STAFF REPORT

SUBJECT: Apex Phenomenal – FP, PS
FP-2025-0005

LOCATION: Generally located 1/2 mile east of S. Meridian Rd./SH-69 on the north side of E. Lake Hazel Rd., in the SE 1/4 of Section 31, T.3N., R.1E.

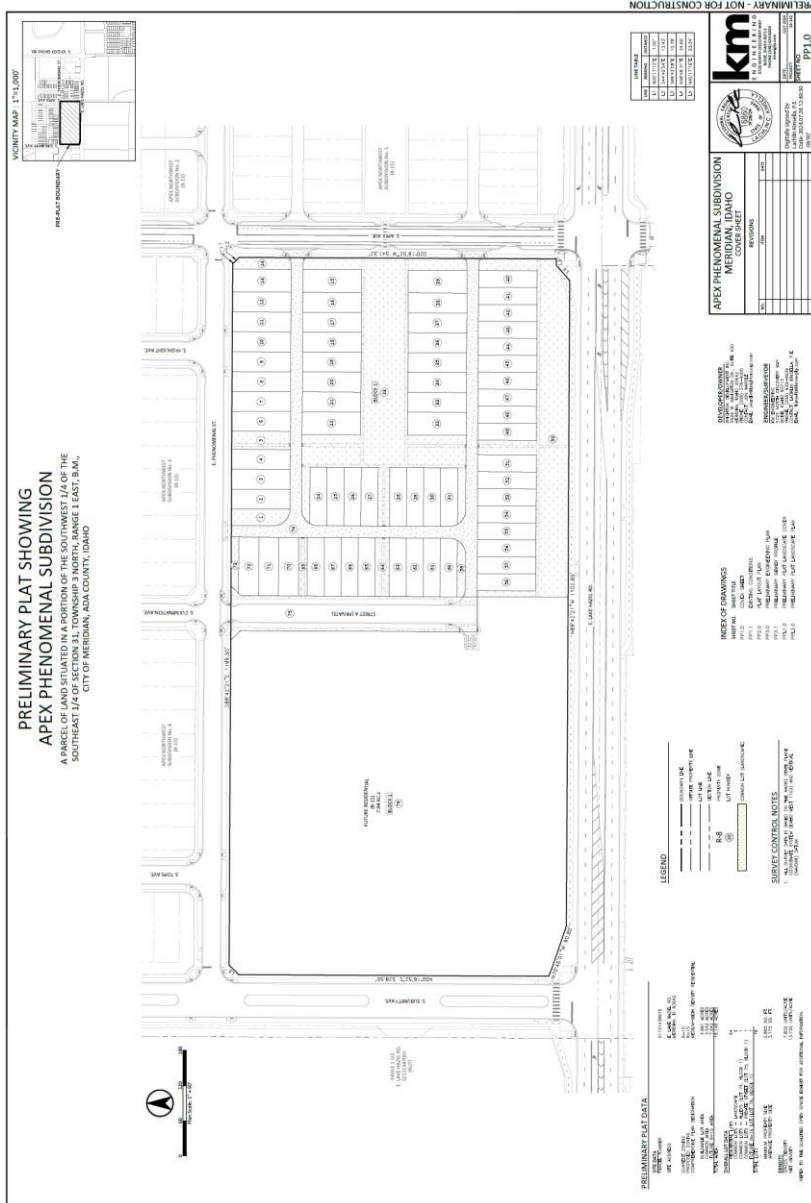
Commented [BP1]: The plat has changed slightly. S. Apex Way is designated collector and after the approval of the plat the plat was redesigned with two additional common driveways to eliminate direct lot access to the collector street. Has there also been a slight increase in open space as result of this change?

A. Preliminary Plat Apex Farr (dated: 7/8/24)

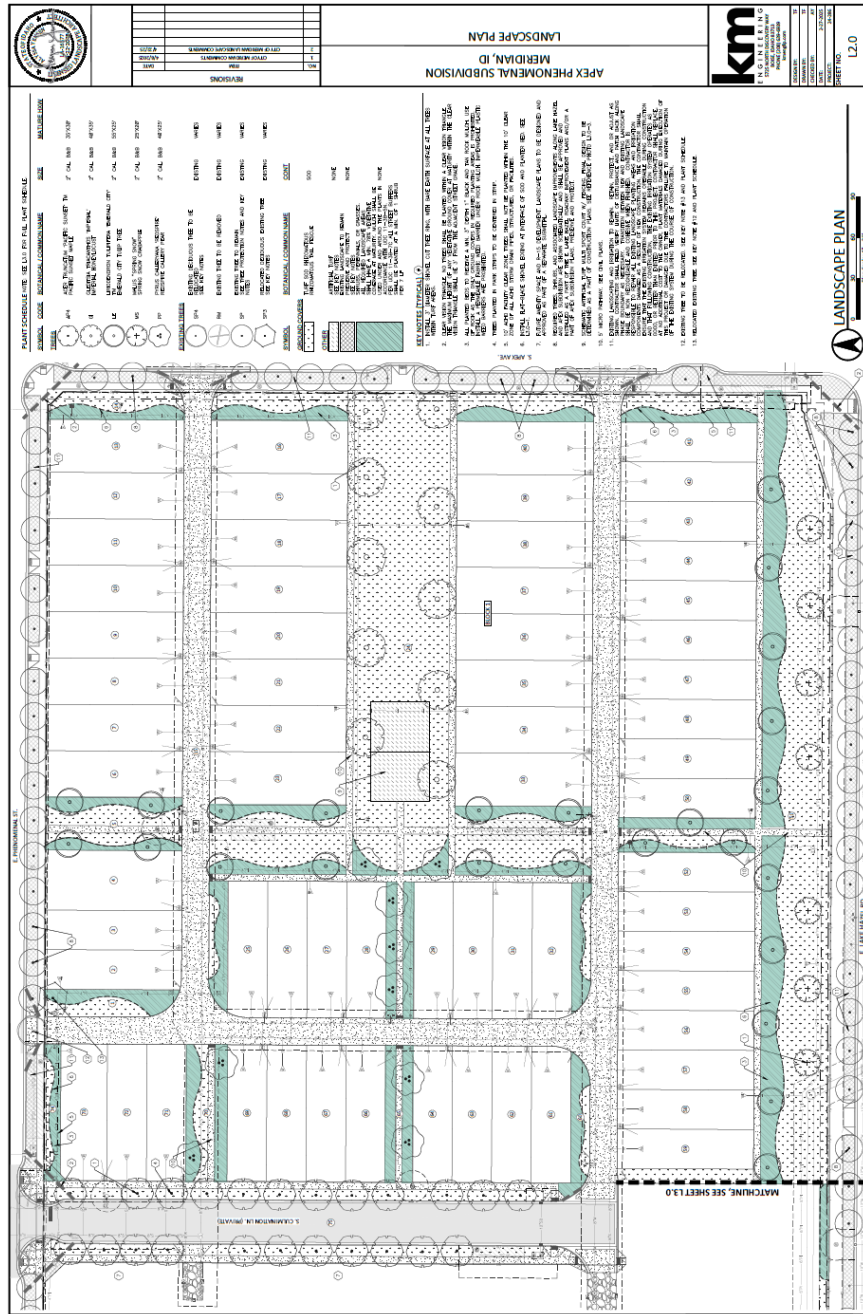
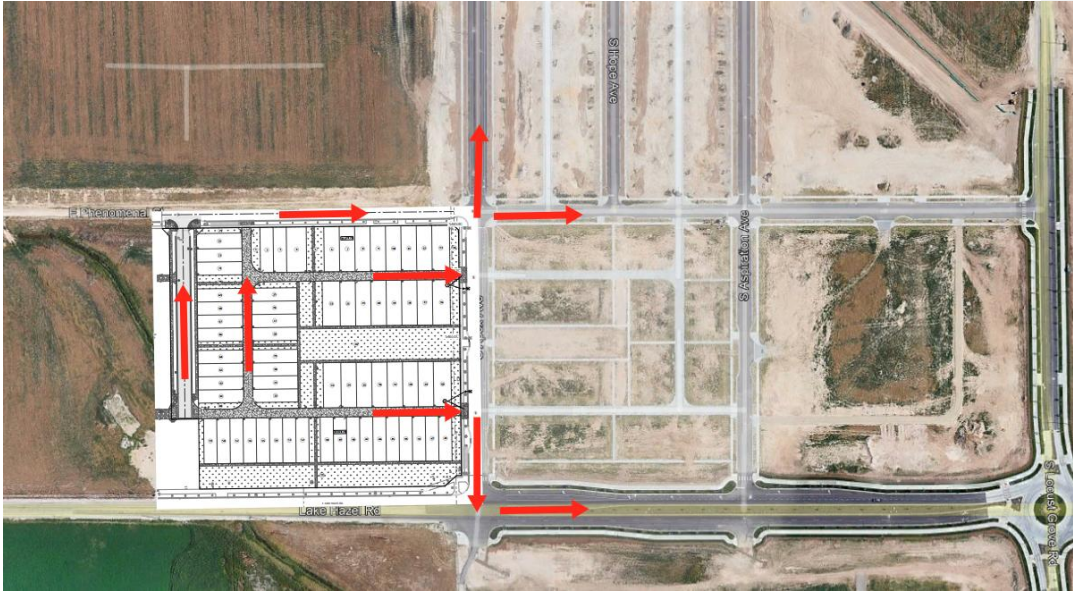
- a. Note #11: Include S. Sublimity Ave.
 - b. Note #13: Include the recorded instrument number of the water and sewer main easement.
 - c. Note #17: Include the recorded instrument number of the ACHD temporary license agreement.

5. The landscape plan prepared by KM Engineering, dated 05/24/2024, included in Section V.C, shall be revised as follows:
 - a. Depict a variety of trees, shrubs, lawn, or other vegetative ground cover within the required street buffers along E. Lake Hazel Rd., Apex Ave. and S. Sublimity Ave., that complies with the standards listed in UDC [11-3B-7C.3](#). See standards for more details.
